19 December 2025

Buller District Council
PO Box 21
WESTPORT 7866

JOHN RAYMOND MCLAUGHLIN – RC250005 REQUEST FOR FURTHER INFORMATION UNDER S92

Right of Way Concept Plans

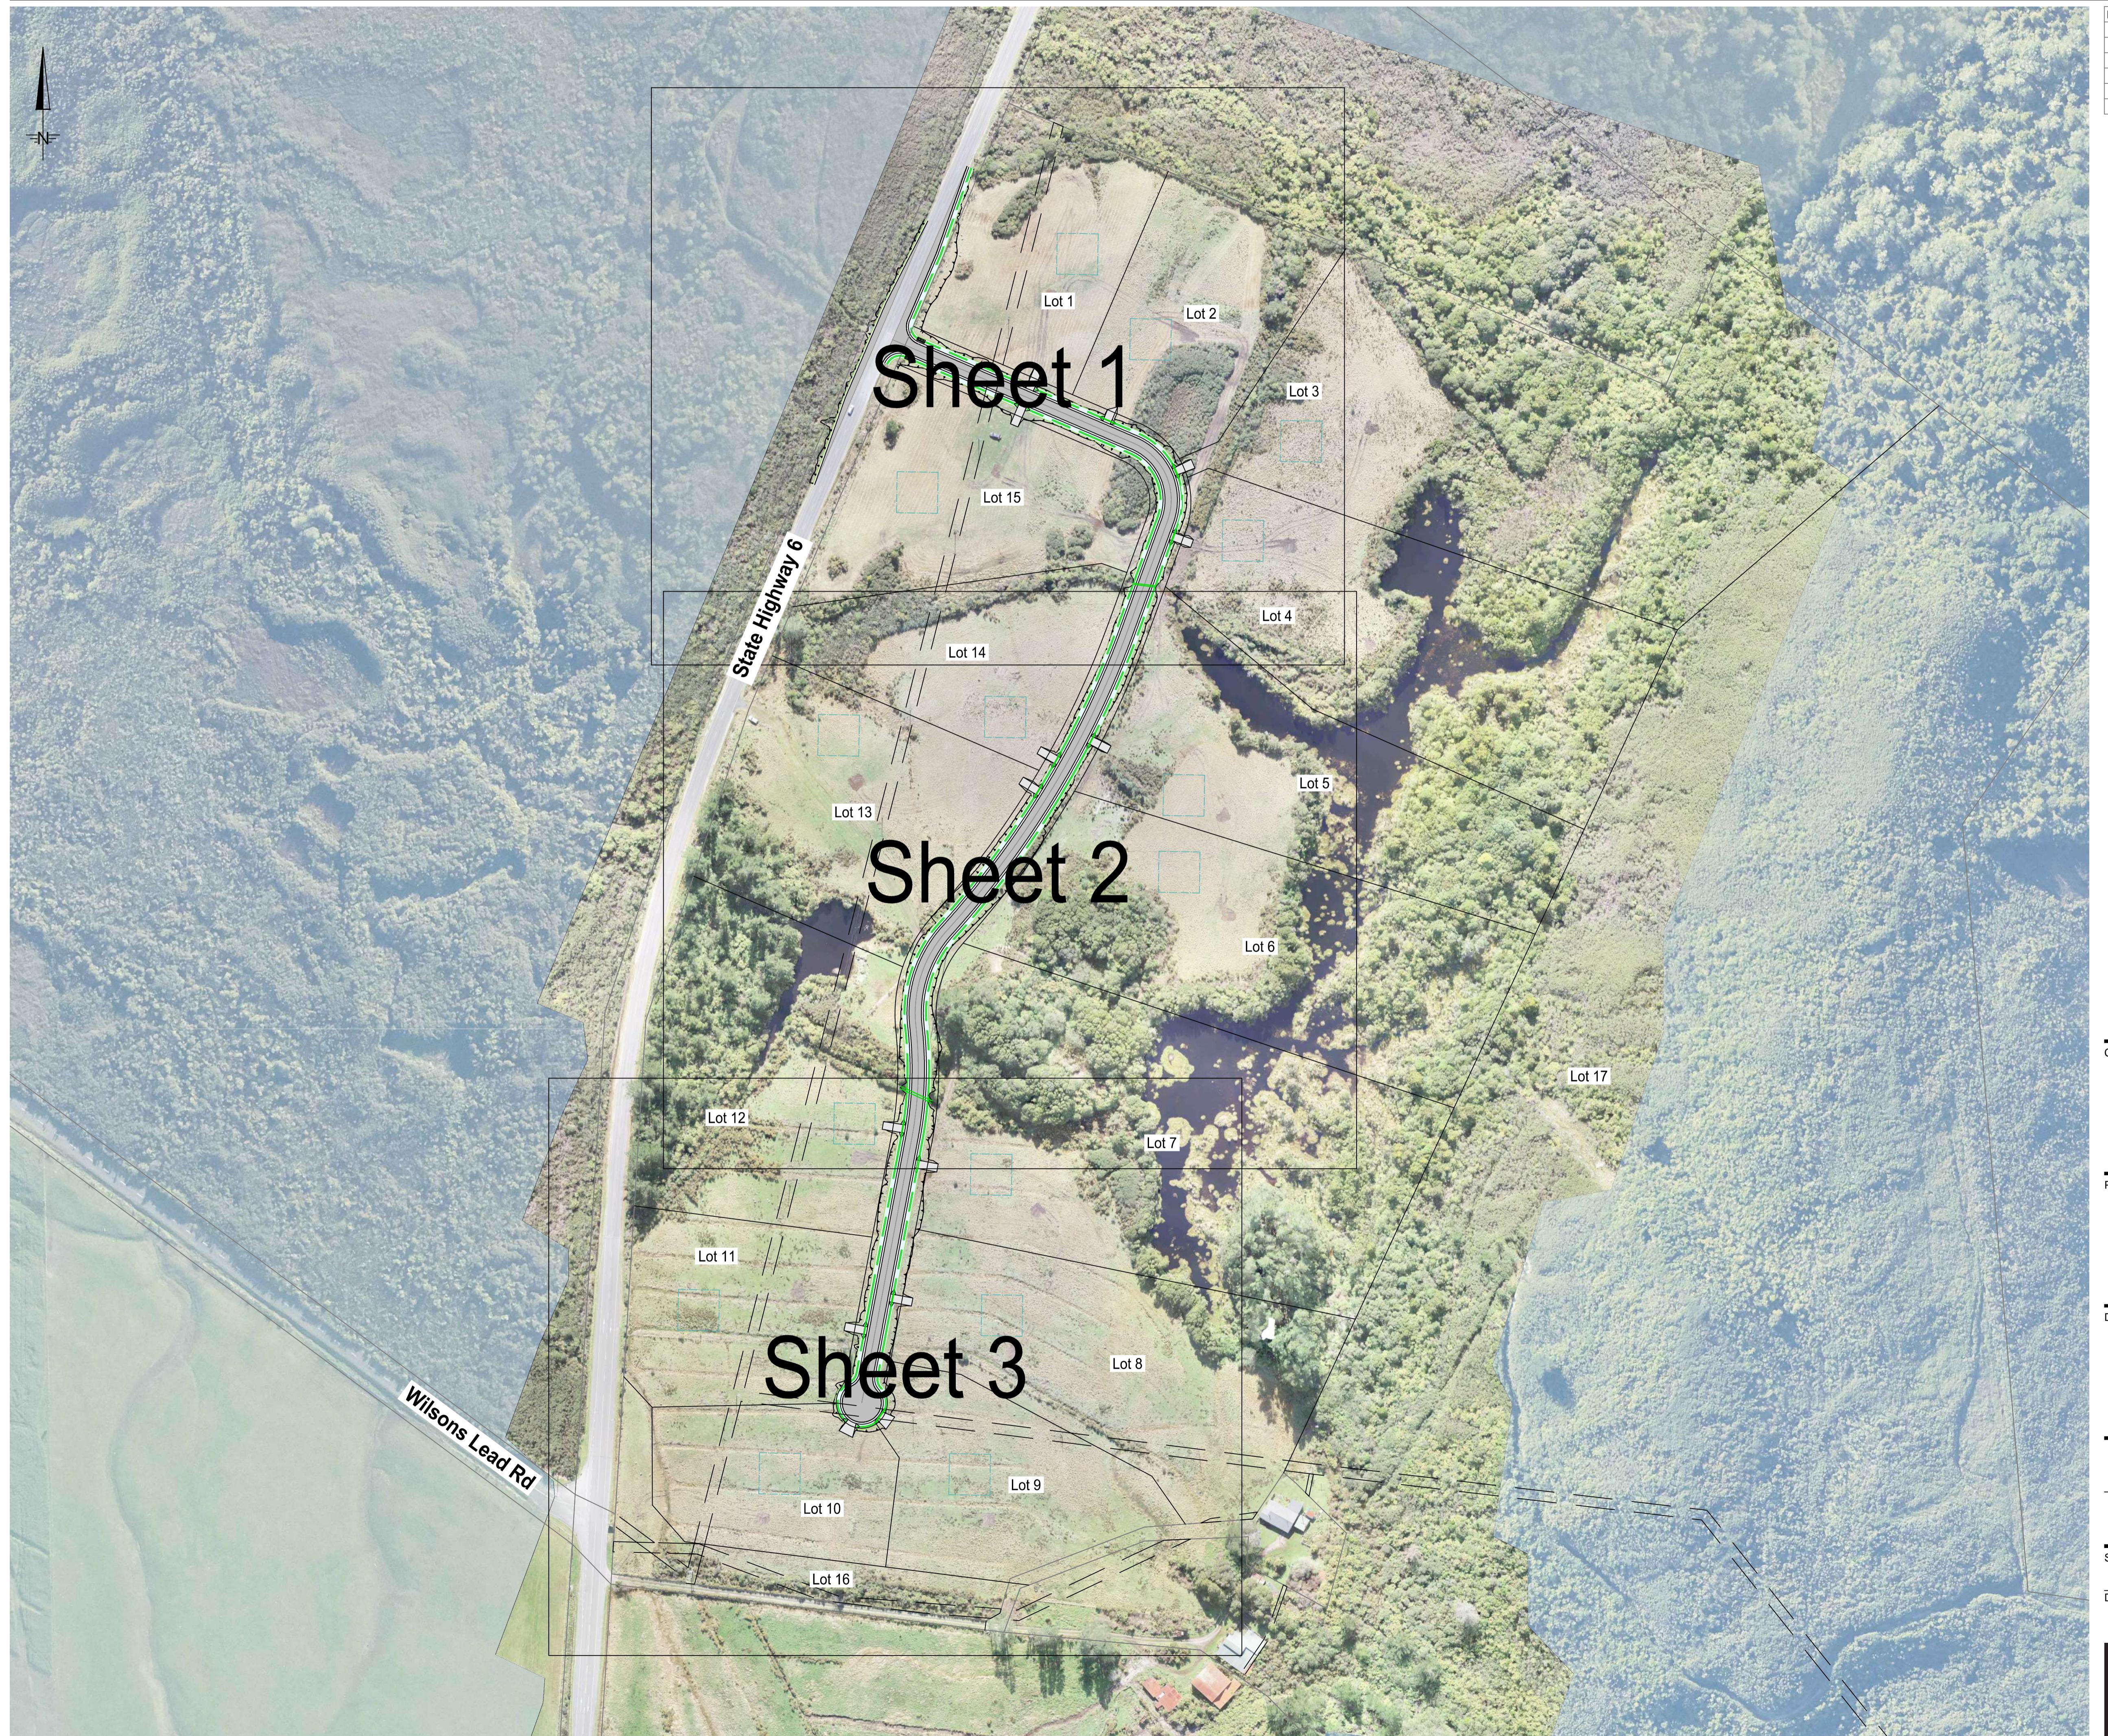
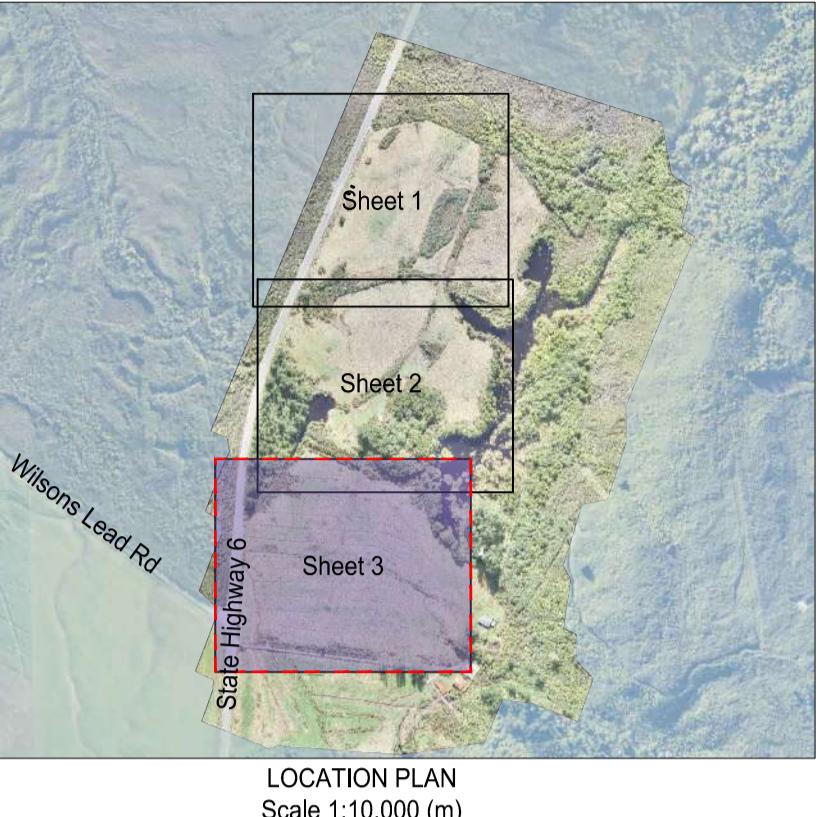
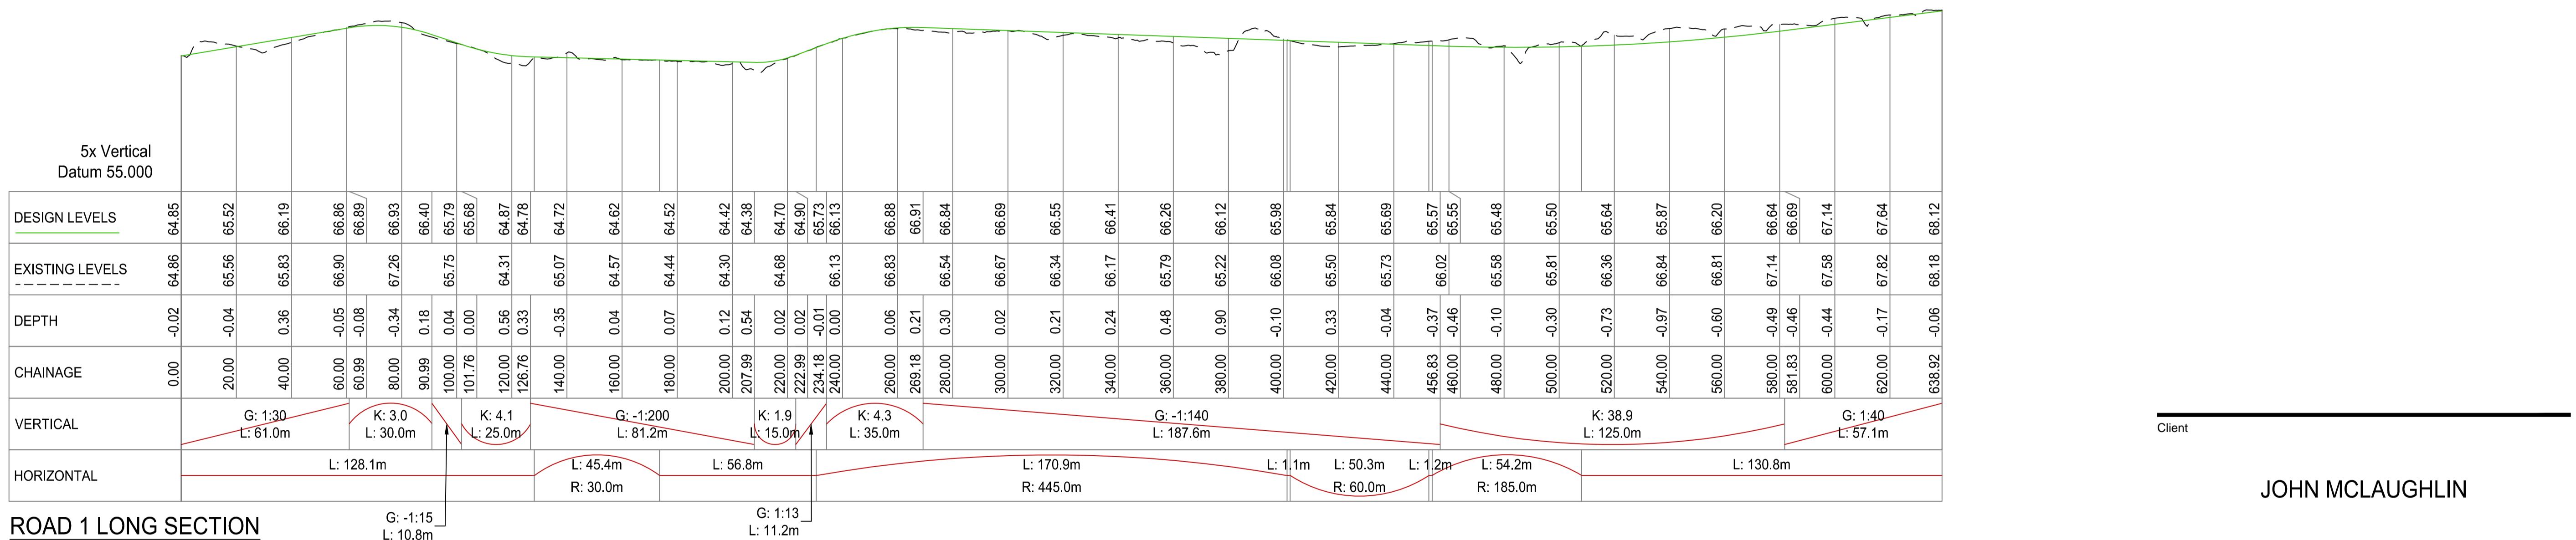
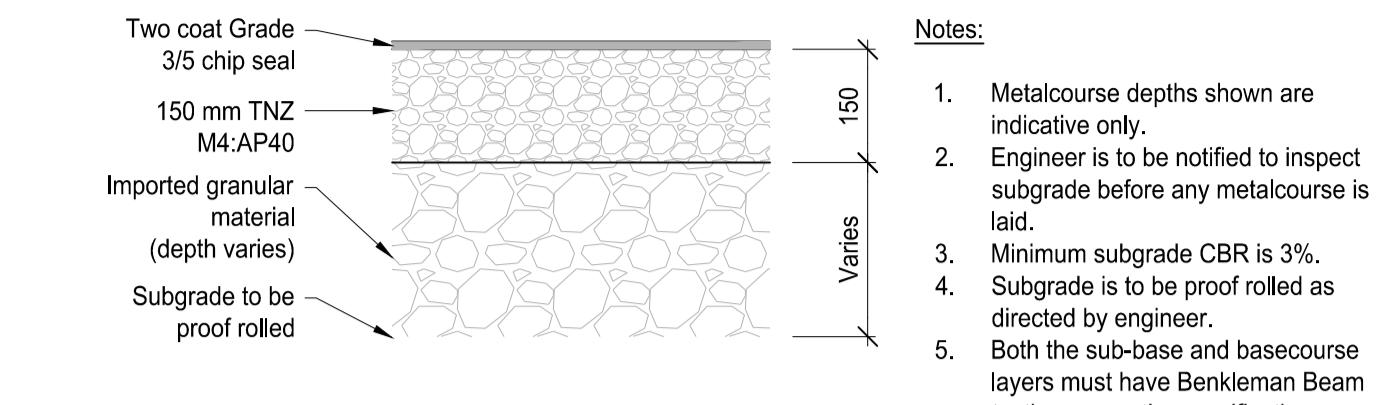
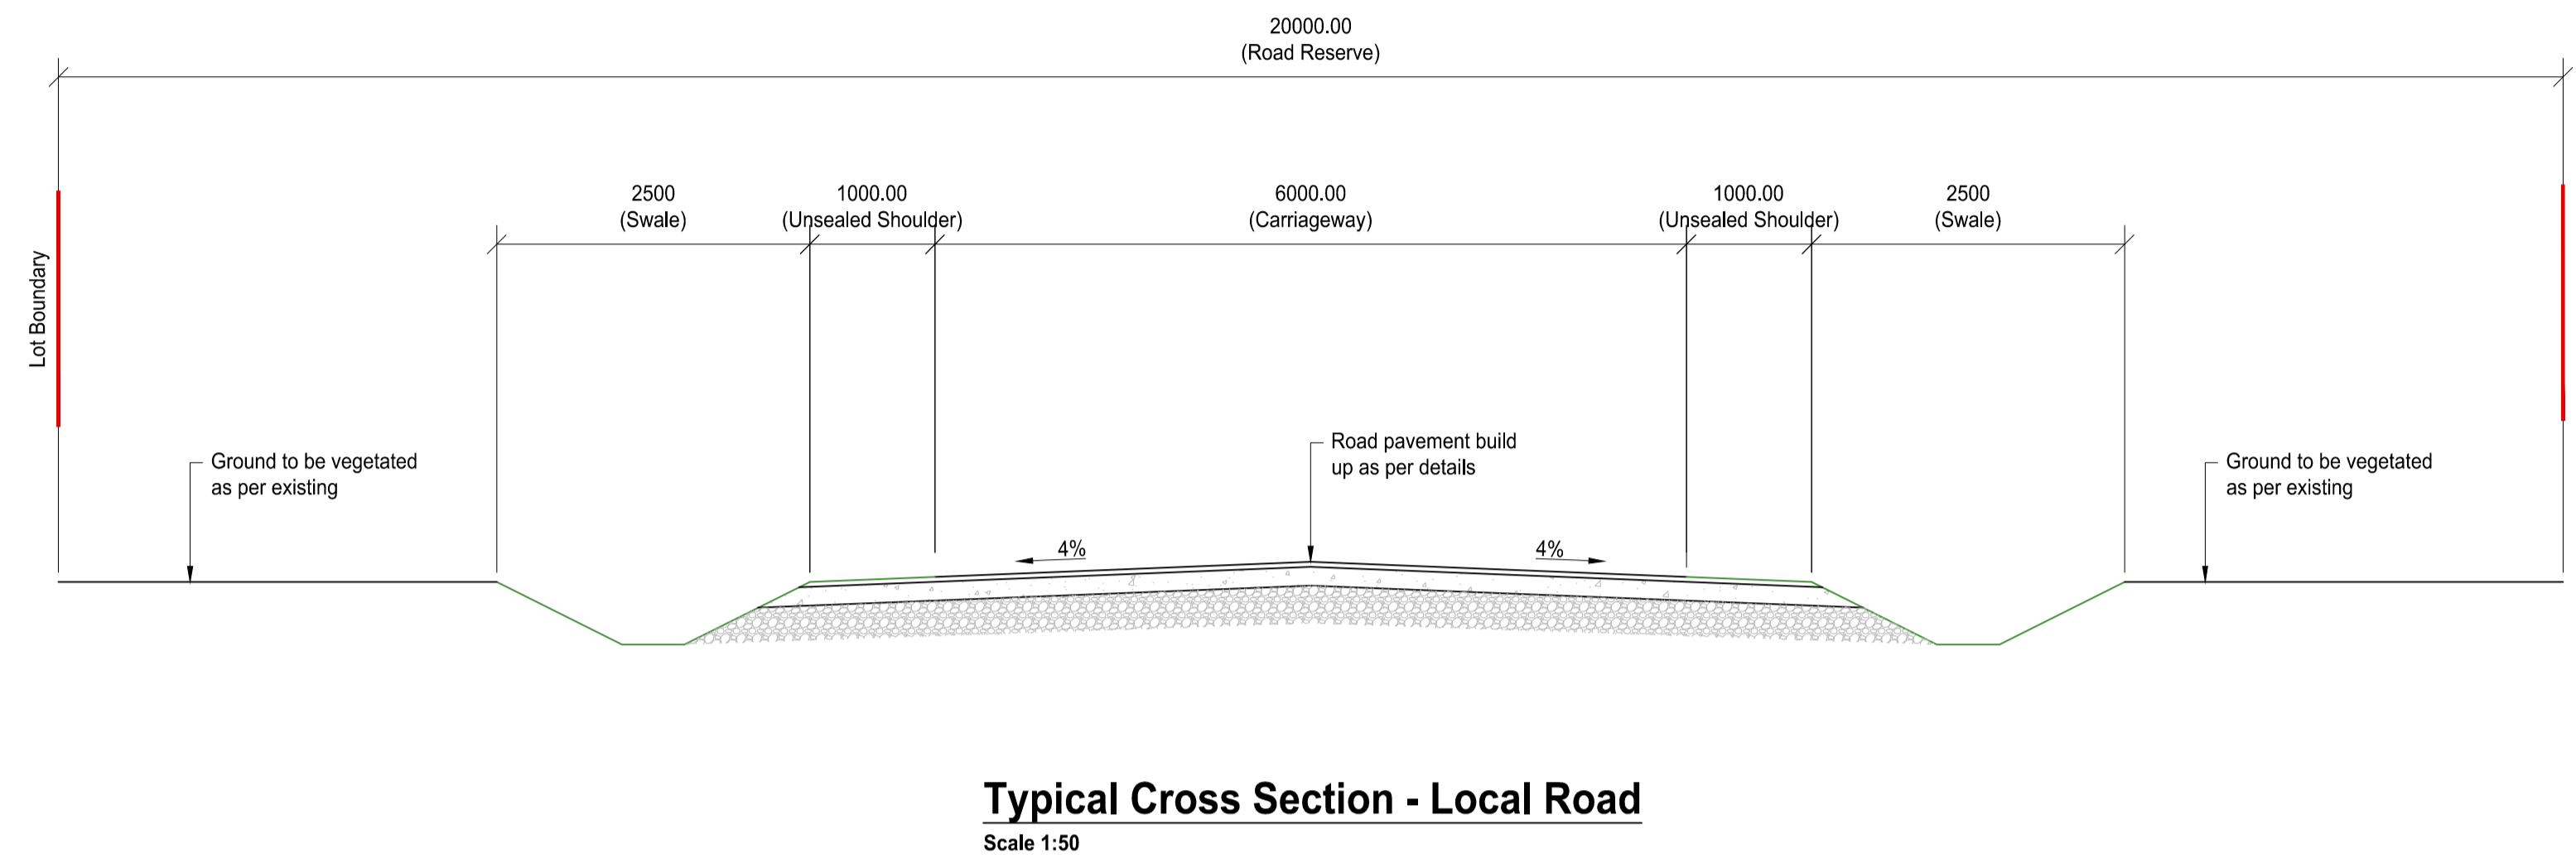
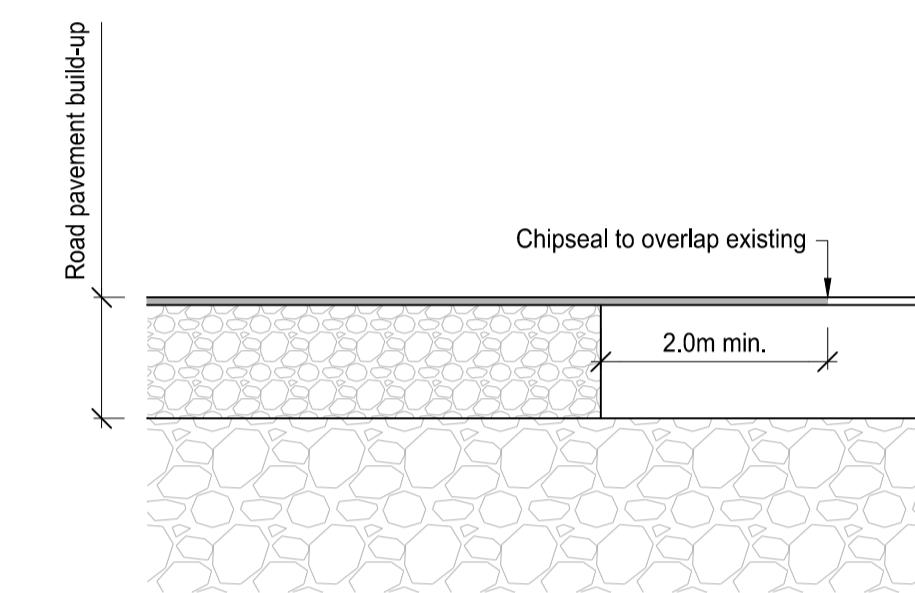
10. Provide a Design and Access Statement, prepared by suitably experienced chartered professional engineer practising in civil engineering, in accordance with NZS4404:2010 for the proposed road/rights of way, including turning head, and vehicle crossings (including stormwater design and any culvert designs/assessment as required). A signed Schedule 1A Certificate must be submitted with the Design and Access Statement.

Point 10 of the RFI letter requires a Design and Access Statement to be prepared by a suitably experienced chartered professional practicing in civil engineering.

The right of way is to be formed and approved as per New Zealand Standard NZS4404:2010 requirements prior to s224 certification. As per Table 3.2 Figure E2 the right of way will have a minimum formation width of 6 metres, with a shoulder width of 3.5 metres. The legal width is to be 20 metres to enable the formation of the right of way whilst proving space to upgrade the right of way to a road if deemed appropriate in the future or if a hearing is held on this proposal and the commissioner deems the right of way should be a road vested in Council.

Concept plans for the right of way are attached as **Appendix D**. These concept plans are to show the initial design of the right of way. Detailed design of the right of way is expected to be required as a condition of consent.

We request that a condition is included in the consent that requires the design and access statement to be completed by a Chartered Professional Engineer practising in Civil Engineering and submitted to Councils Infrastructure Services department for approval prior to the construction of the right of way. This will enable the engineers to assess the ground conditions in more detail and create a detailed design that accurately reflects the specific ground conditions, while meeting the requirements of NZS4404:2010. The design and access statement will then ensure the design is assessed against the requirements of NZS4404:2010 including, but not limited to, the road dimensions and layout, link and place functions, connectivity, how target operating speeds will be achieved, and the management of stormwater. It will also evaluate the effects of the proposed subdivision on the surrounding communities and network. Requiring the Design and Access Statement to be provided to Council prior to design and construction as a condition of consent, is considered the best, most practical and feasible option to ensure the right of way is accurately designed and constructed to reflect the nature of the landscape.
